Network Video Recorder

Version: V4.30.005 build 200628

Release Note

Firmware Basic Information	Firmware Version:	4.30.005build200628
	SDK Version:	V6.1.4.20_build20200320
	Play Library:	V7.3.7.39
	Web component:	V4.0.1 build200507
	OpenSDK Version:	V2.5.0

1. 【Support adding motion detection 2.0 IPC】

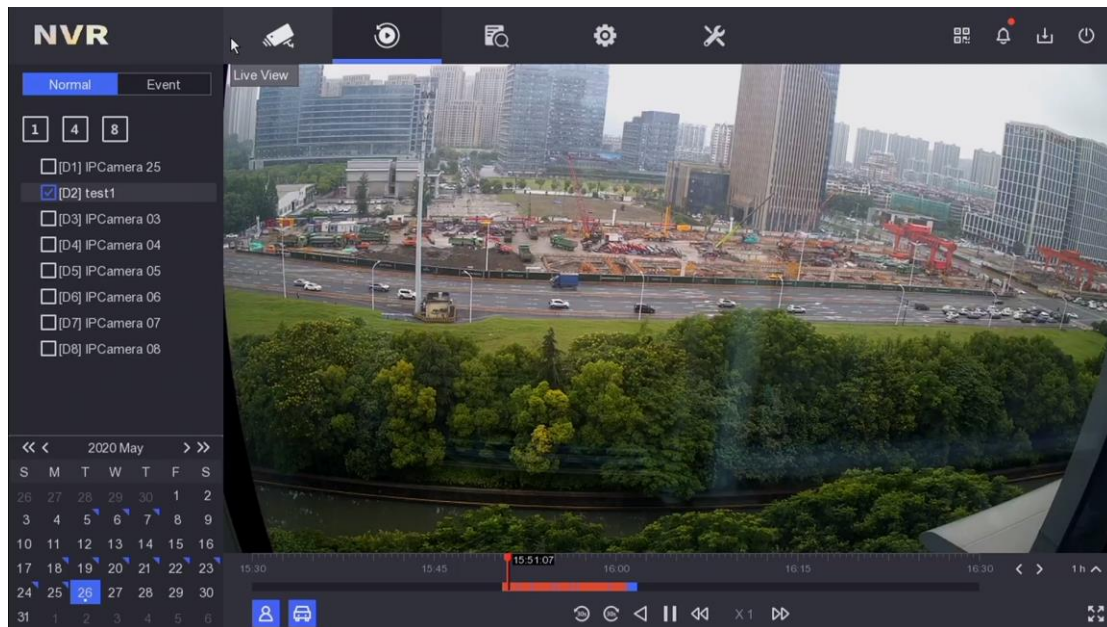
1) Support IPC with motion detection 2.0 function, the specific model of IPC is DS-2CD20 (23 / 2T / 26) 2 (4/8) 6G2-I / SL, such as: DS-2CD2026G2-I / SL. The firmware version of IPC is required to be V5.5.130 and later.

2) Support the local GUI, IE and 4200 to configure the target filtering of human body and vehicle.

The smart playback interface for local playback and the remote ordinary playback interface add the option of human body-vehicle filtering. After checking, the human body-vehicle video information will be marked in red on the progress bar.

2. 【Support access in ISUP 5.0 protocol】

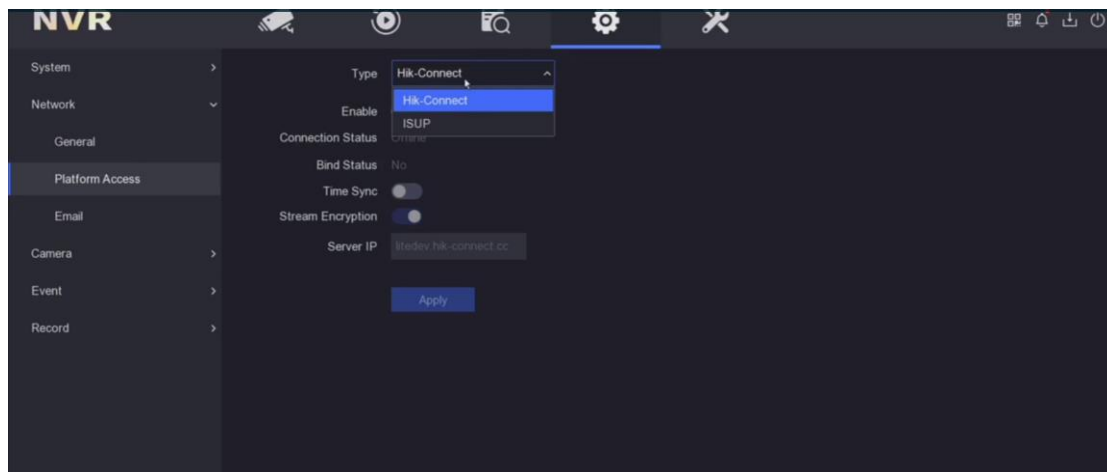
- 1) Overseas product support adding ISUP 5.0.
- 2) Support the configuration of preview, playback, two-way audio and FTP upgrade.

3. 【Support Hik-Connect to enable One-Key Do Not Disturb function】

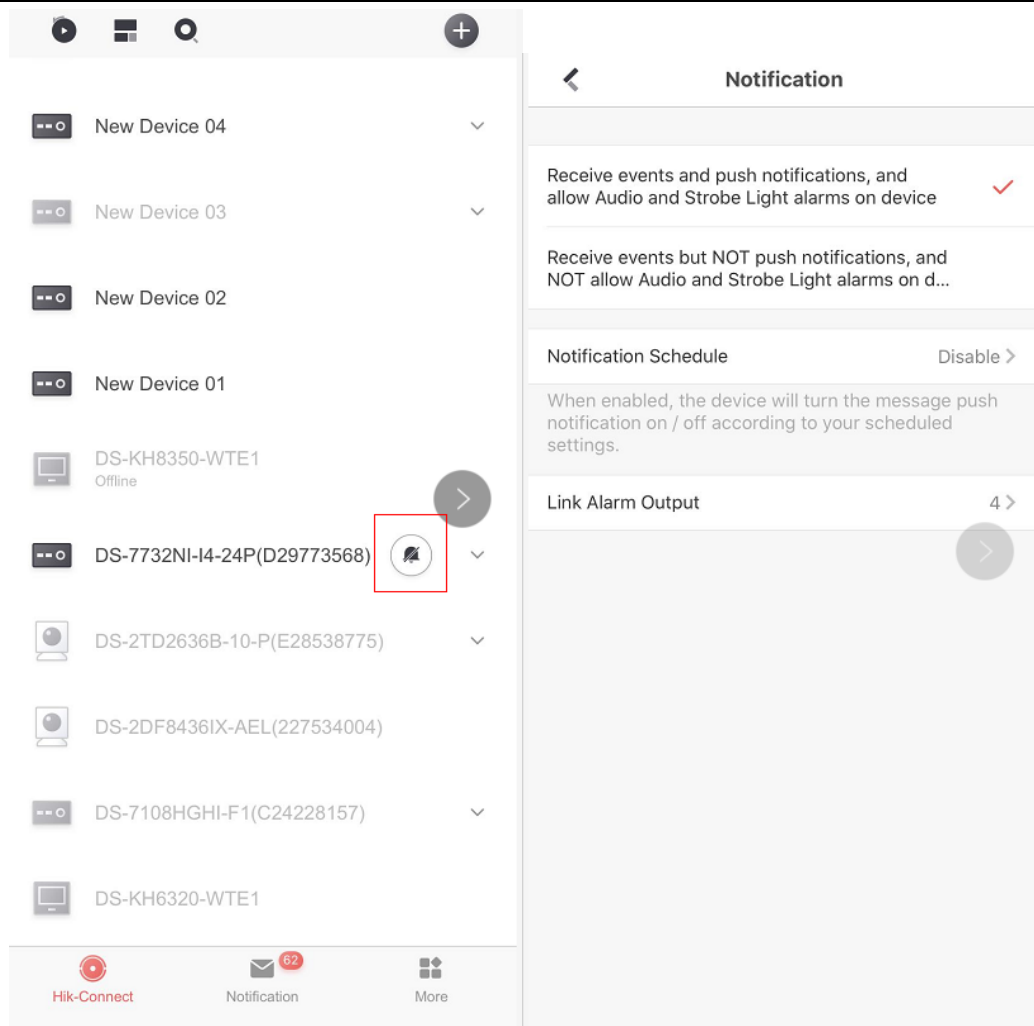
- 1) After Hik-Connect enables the One-Key Do Not Disturb function, all event linkage action will be cancelled.

4. 【Support Hik-Connect / GuardingVision to scan NVR QR code to recover password】

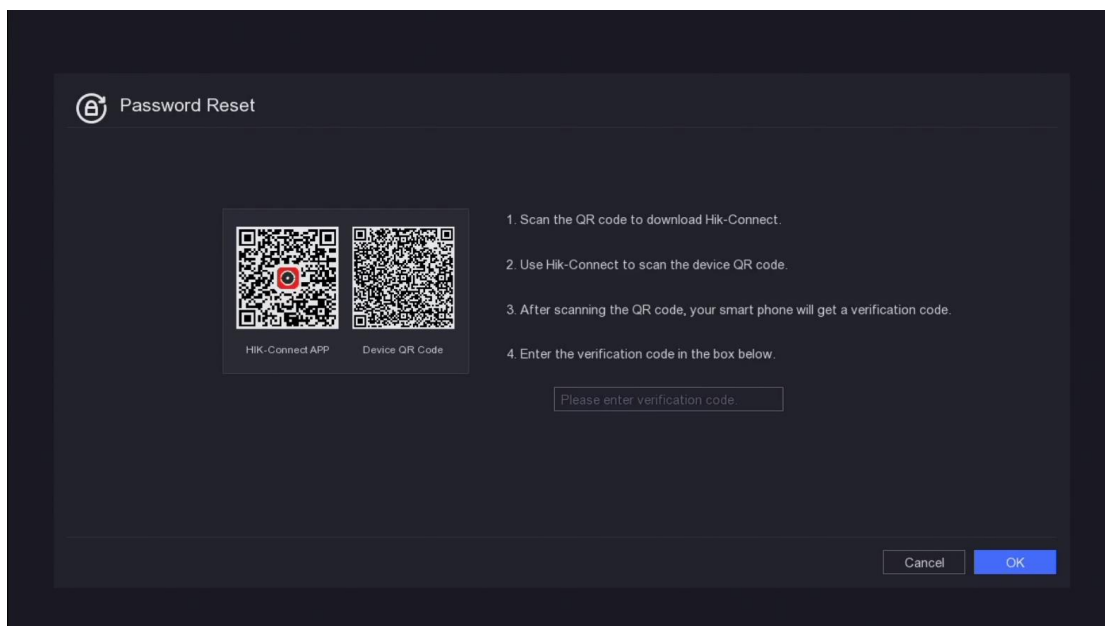
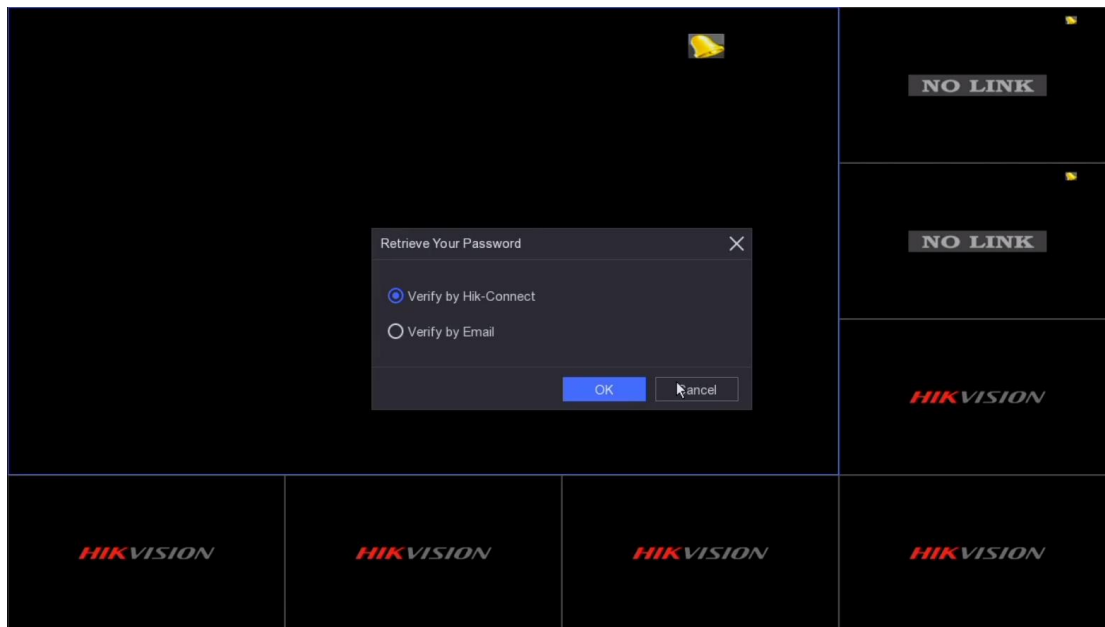
1) Support local HC / GV scanning QR code and mailbox to recover password, Local GUI delete the recovery way of GUID and security issues; WEB still retain GUID, security issues and mailbox to recover password.

2) Only the NVR that has been bound to the HC / GV will display the option to scan the code to recover the password.

3) Only the NVR-bound HC / GV client account can successfully recover the password.

4) Require HC/ GV v4.3.0 and later.

5. 【Support GUI local online upgrade by Hik-Connect】

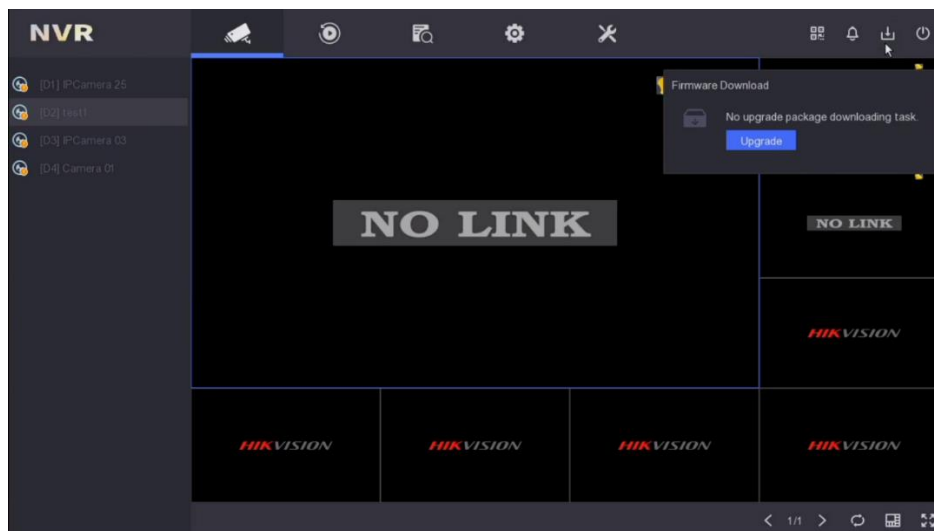
1) Support IE, GUI local Hik-Connect online upgrade.

2) Support HC remote upgrade

3) Remote upgrade will be pushed to the main menu interface, there will be a red dot prompt in the upper-right corner of the main interface

6. 【Support event recording search in Hik-Connect client】

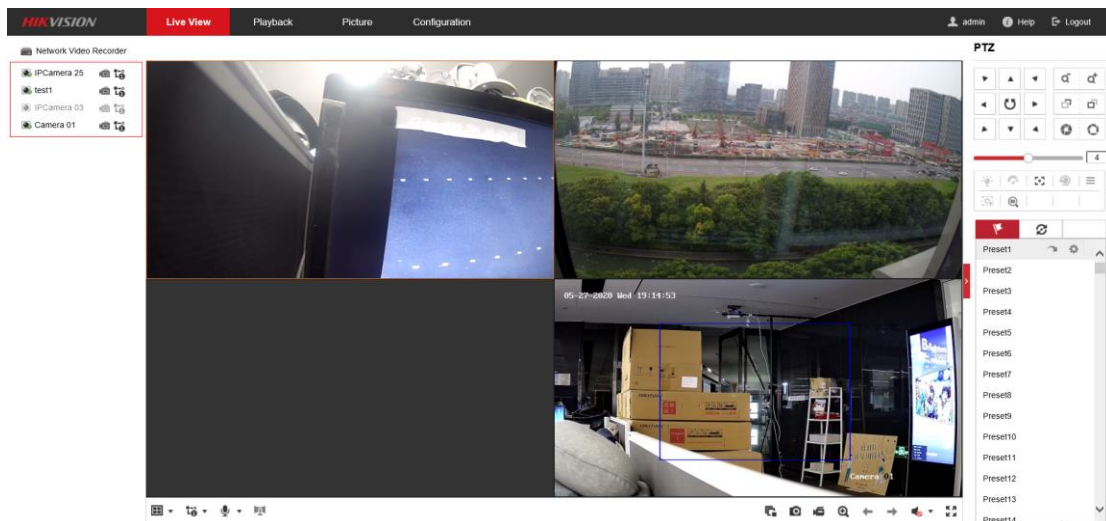
Support event recording search in Hik-Connect, continuous recording progress bar with light orange and event recording progress bar with deep orange.

10. 【Optimization of PoE exception information display】

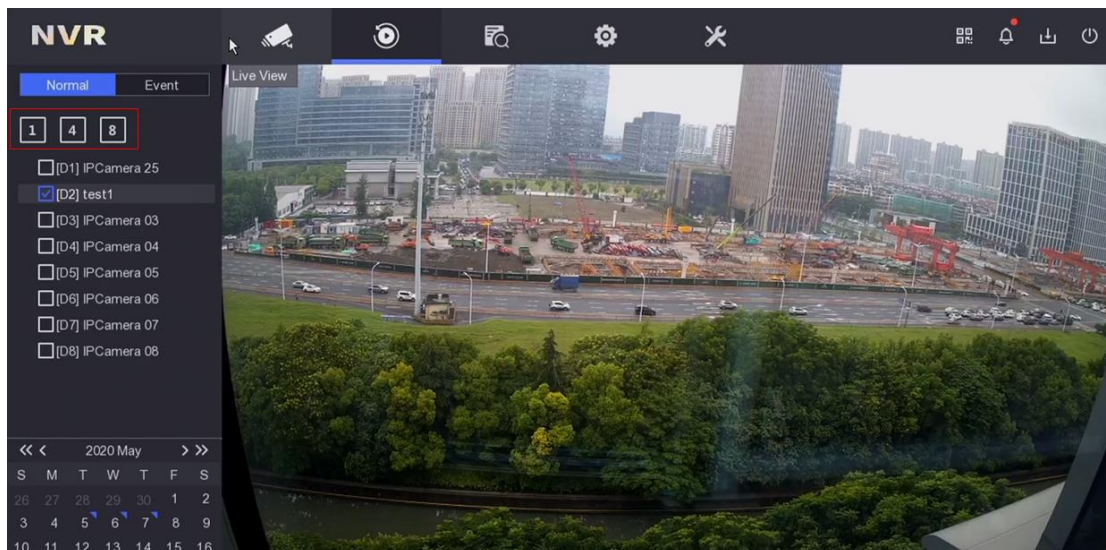
- 1) When switch connect to NVR PoE port, no short-circuit or error information will display.

2) Cameras that link with Switch which connect to NVR PoE port, could also connect to NVR through this switch.
